February 14, 2023

**Re: Comments on Sunrise Wind DEIS; Docket No. BOEM-2022-0071**

Figure 2. Number of Fish Larvae Entrained per Month

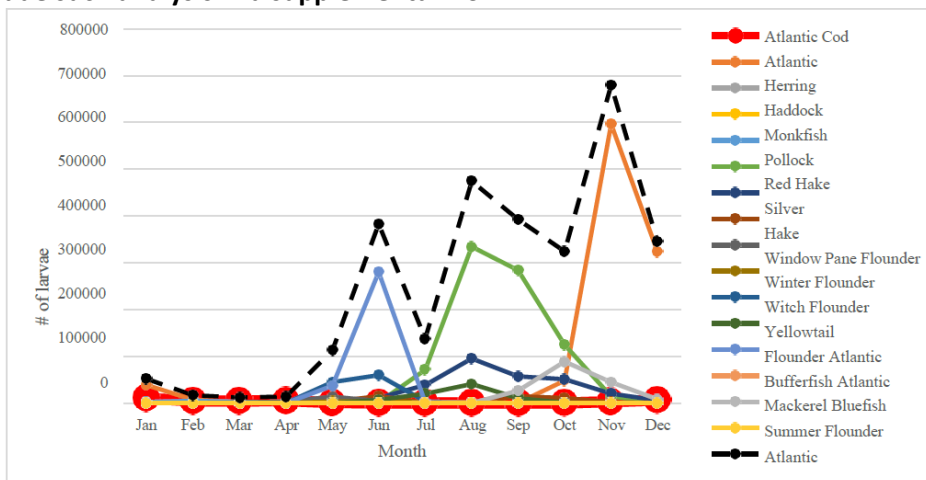
If the document is faulty on that very simple subject, we do not have confidence that it is correct on any more complicated aspects of analysis. Furthermore, it does not include "l[]arger marine invertebrates, such as the Atlantic sea scallop" in the scope of its "analysis" despite the fact that BOEM's DEIS identifies Atlantic sea scallops as producing \$3.2 million of revenue in the lease area.<sup>35</sup> However, we particularly voice our concerns with the significant number of butterfish larvae projected to be entrained by the OCS-DC according to that document. A table from that document, reproduced below,

shows butterfish larval death alone (incorrectly written as “bufferfish”) as driving the entire “Atlantic” species mortality for a good part of the year. As a company whose vessels rely heavily on the butterfish fishery and which are responsible for the majority of all US landings for that stock, we are very concerned. The butterfish stock has recently undergone a research track assessment by the Northeast Fisheries Science Center, and butterfish recruitment (i.e. eggs/larval/young of the year production) was a major focus of that assessment. Any Project induced impacts to that recruitment could have impacts on future stock status and stock assessments. **We therefore request that BOEM conduct the necessary analysis to demonstrate quantified impacts to the butterfish stock as a result of the Proposed Action and include such analysis in a supplemental EIS.**
